### Manfield Preliminary Plan No. 120160360

Staff Report Date: July 10, 2017

### Description

**Recommendation:** Staff recommends approval of Preliminary Plan No. 120160360, Manfield Property, for two one-family lots subject to the following conditions:

Figure 3: Proposed Preliminary Plan

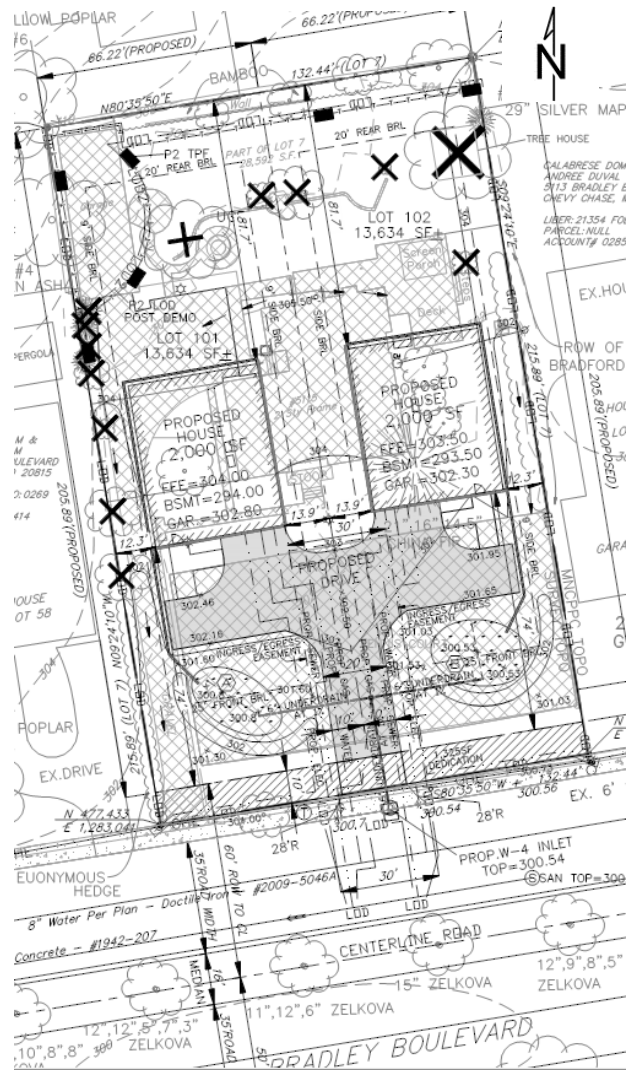
As shown on the submitted Preliminary Plan, the Project will dedicate a 10-foot wide strip across the site's entire frontage for a total of 1,325 square feet. This dedication will provide the minimum width of 60 feet between the property line and the MD 191 right-of-way centerline. This dedication supports the Master Plan recommendation for a right-of-way width of 120-feet on MD 191 and is a recommended condition of approval.

The Project proposes eliminating the site's existing driveway from MD 191 in favor of a single right-in/ right-out shared driveway located in the middle of the site's frontage on MD 191, approximately 53 feet east of the existing driveway. The proposed access concept is preferable to the existing condition because it consolidates access to a single point between the two proposed lots.

Currently, the proposed driveway location is improved with a storm drain inlet that must be relocated outside of the proposed driveway apron to facilitate safe and adequate vehicular ingress/ egress. MSHA may permit the driveway to be constructed around the existing inlet or in the alternative require the Applicant to relocate the inlet along the site's frontage. Staff recommends a condition of approval to address the storm drain inlet.

7. The record plat must show a common access easement from Bradley Boulevard (MD 191) over the shared driveway.
8. Prior to recordation of plat, the Applicant must satisfy the provisions for access and improvements as required by Maryland State Highway Administration (MSHA) including relocating the existing storm drain inlet outside the limits of the proposed driveway apron, unless this requirement is waived by MSHA.

9. The Applicant must dedicate 10-feet along the Subject Property’s frontage as mandated by the 1990 *Bethesda-Chevy Chase Master Plan* and as shown on the Preliminary Plan.
